NUCLEAR REGULATORY COMMISSION

Structural Analysis Subcommittee

Date: November 17, 2014

Treatment of Uncertainties in Probabilistic Seismic Hazard Analyses (PSHA) Conducted for Combined License Applications and Early Site Permits

**25 Hz Seismic Hazard Curve Calculated
Using the CEUS-SSC Model at the Fermi 3 Site**

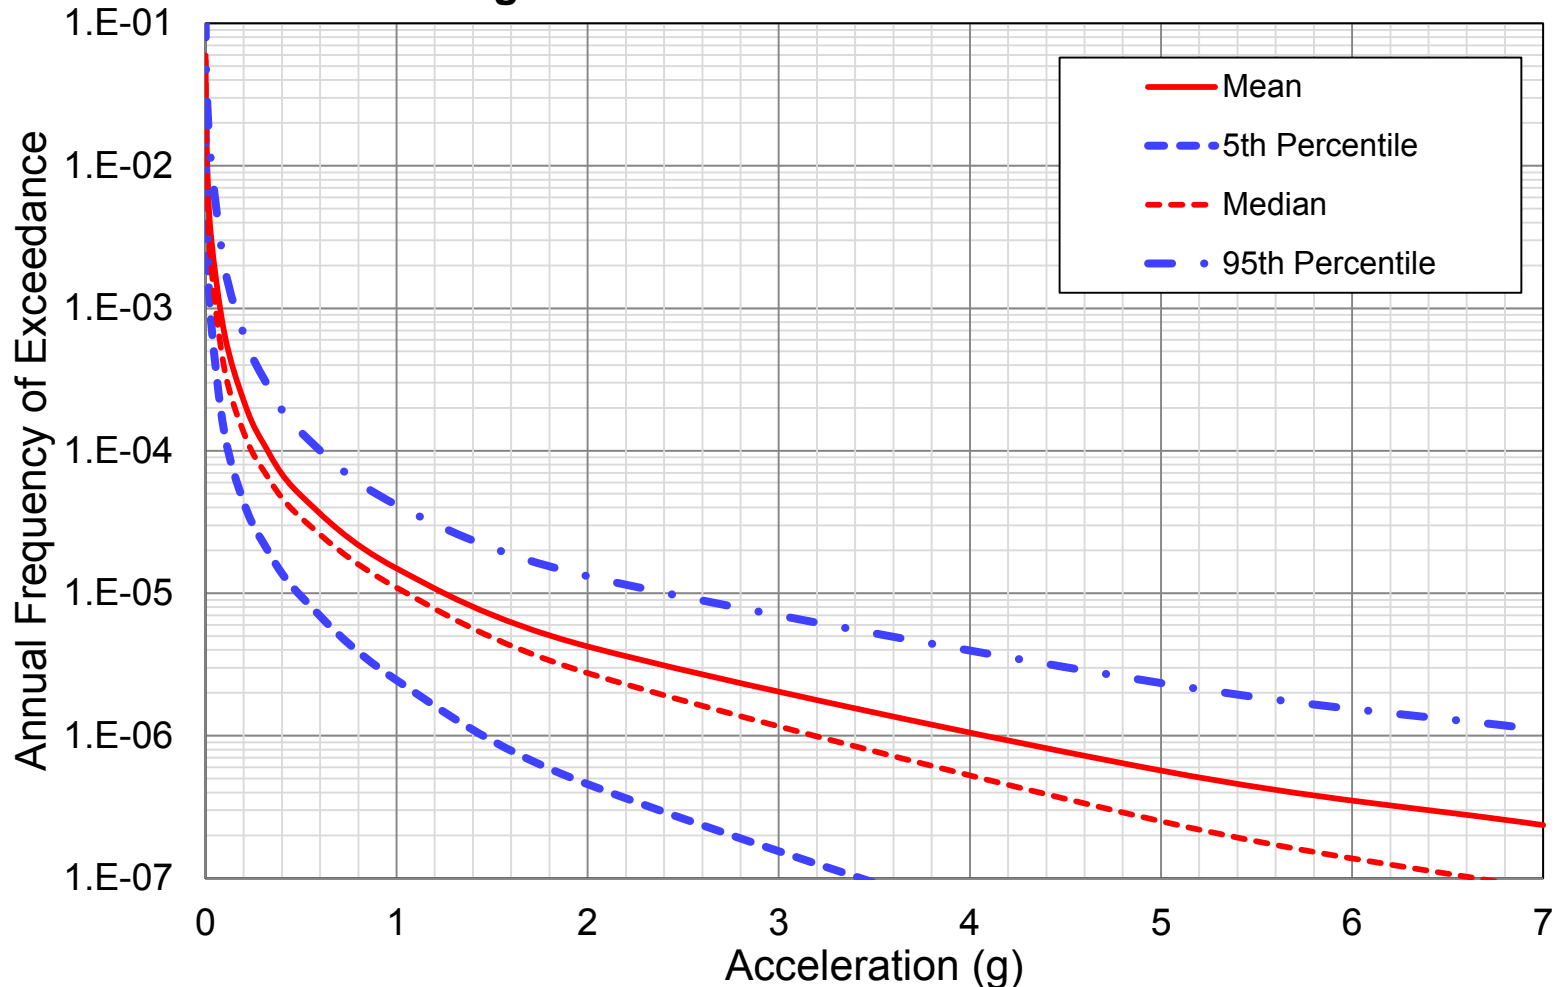
1. Why doesn't the uncertainty increase appreciably as you go from small spectral accelerations to very high spectral accelerations?

Fermi 3 Site 0.5 Hz Seismic Hazard Curve
(CEUS-SSC Model)

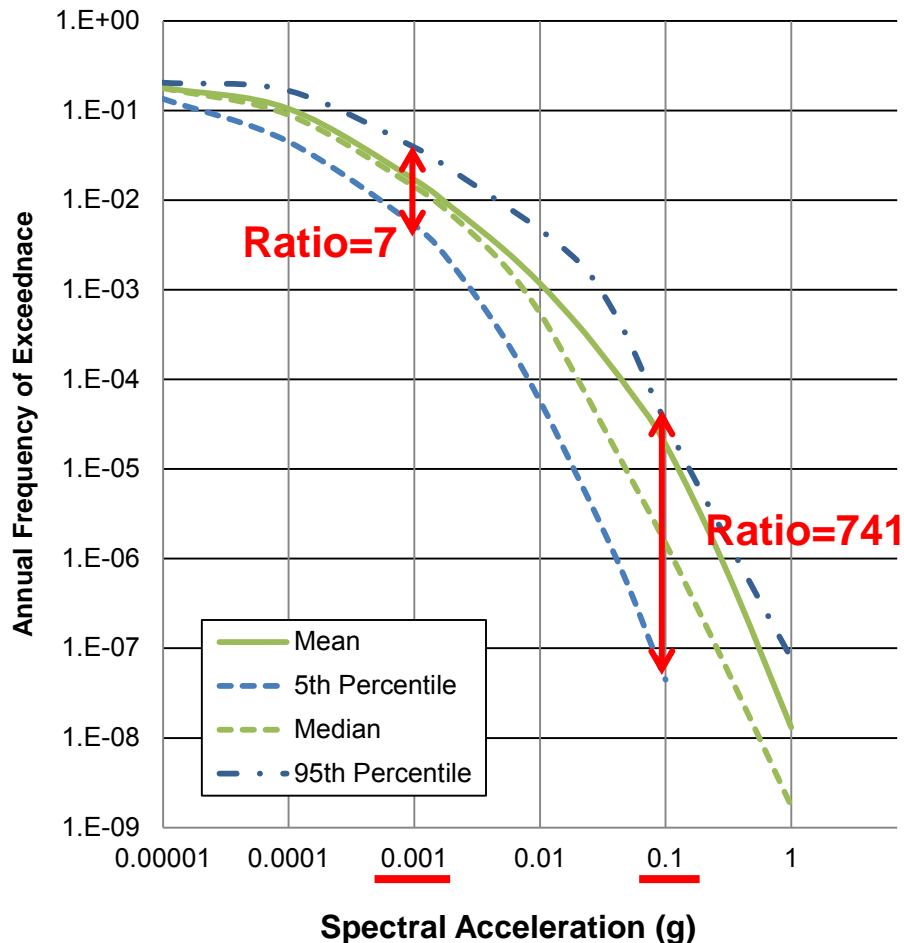
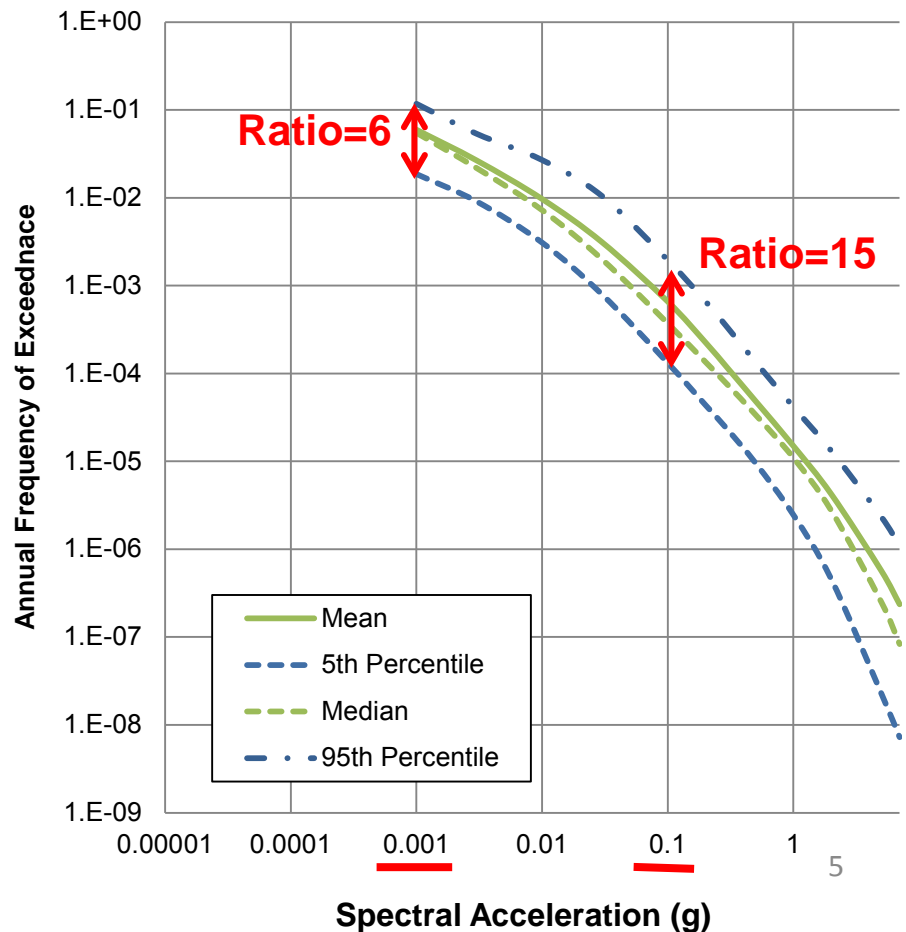
2. Why is the uncertainty small for very high spectral accelerations at 25 Hz when compared to the uncertainty for very high spectral accelerations at 0.5 Hz?

Fermi 3 Site 0.5 Hz Seismic Hazard Curve
(CEUS-SSC Model)

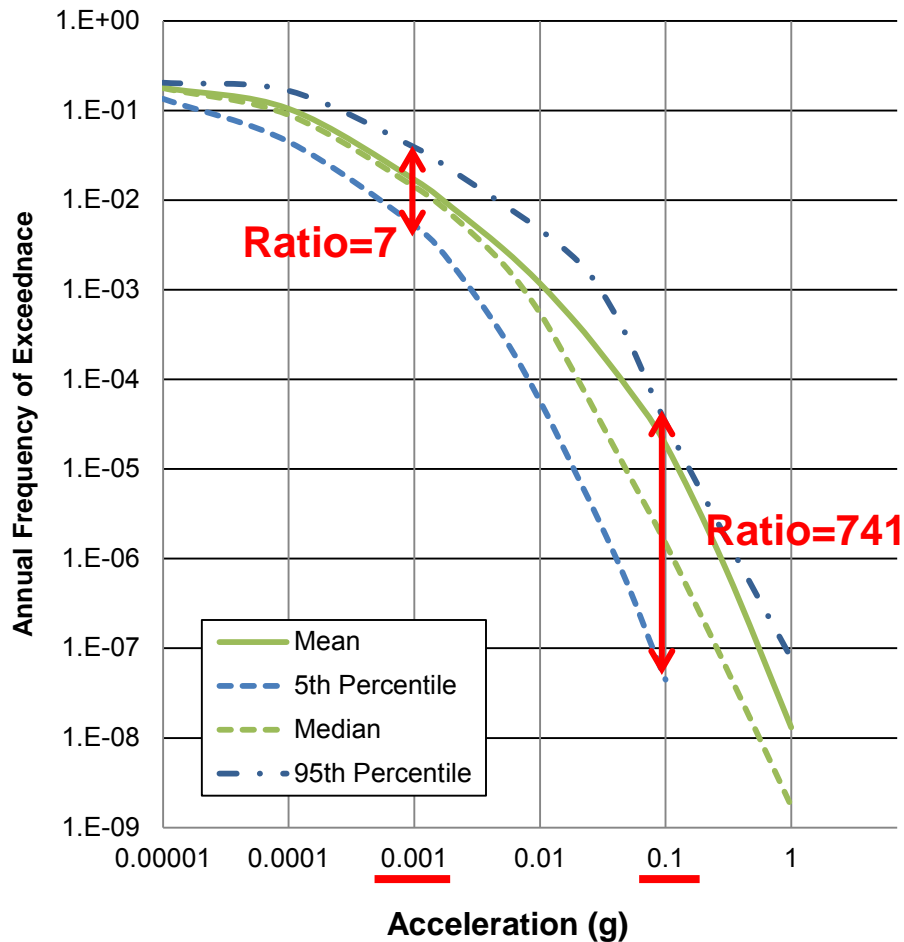
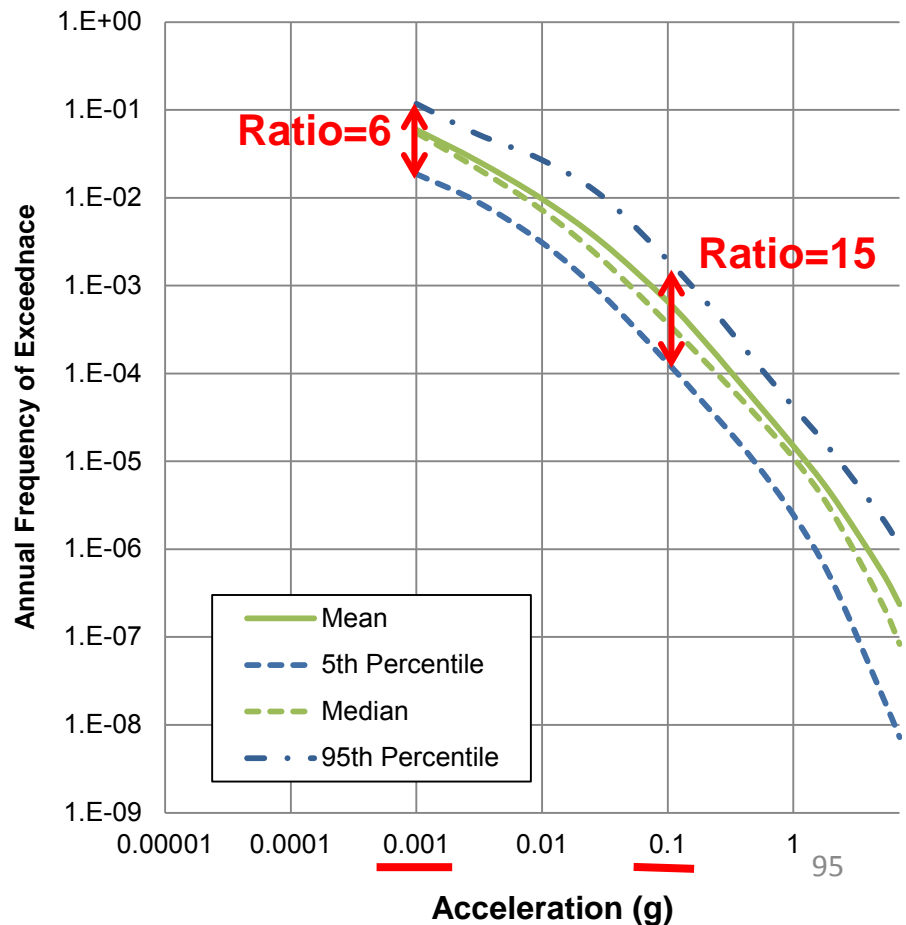
2. Why is the uncertainty small for very high spectral accelerations at 25 Hz when compared to the uncertainty for very high spectral accelerations at 0.5 Hz?

Answer to Question 2 (1/2)
